# DEVELOPMENT REVIEW BOARD REPORT

CASE NUMBER/ 88-DR-2004

Arabian Library Phase 2 Expansion

REQUEST Request site plan and elevations approval for new library building.

3|southwest elevation

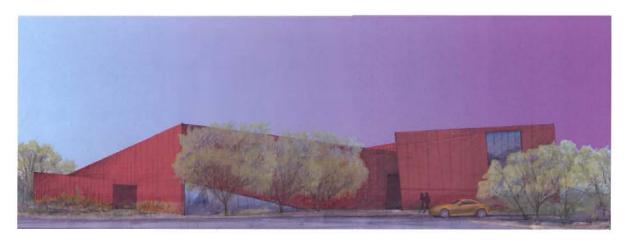
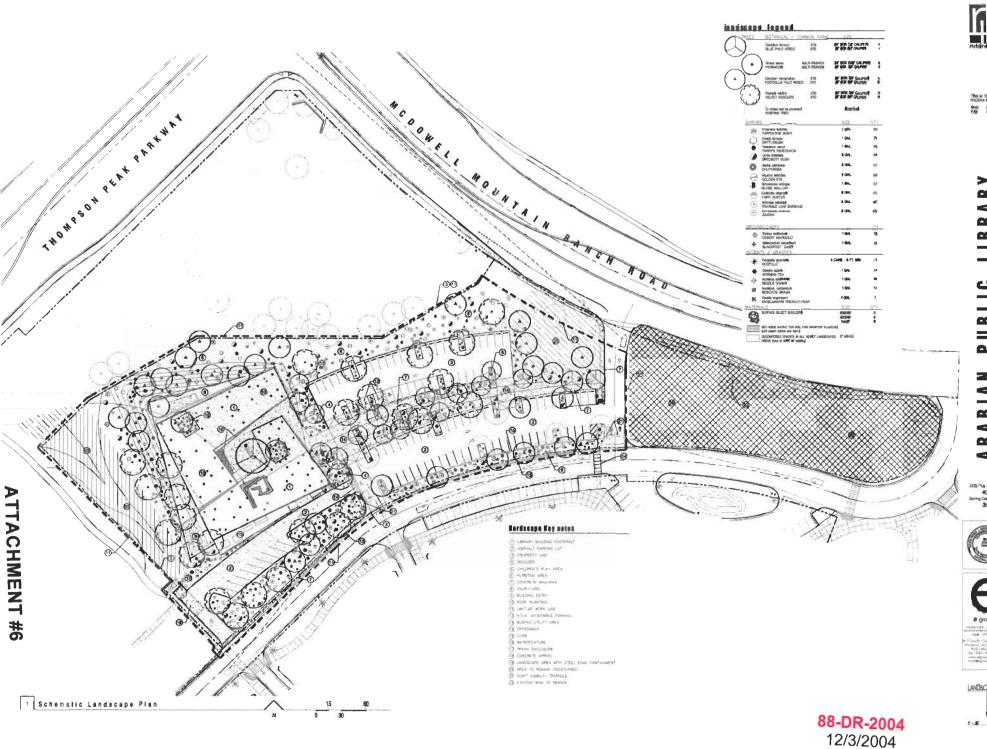
A. The maximum height of the building shall not exceed thirty (30) feet in height as measured from natural grade, per the amended O-S zoning development standards. Revise building elevations to lower building height.

B. The colors of paint shall not exceed a light reflective value of 40. All colors and materials LRV's shall be clearly indicated on the building elevations.
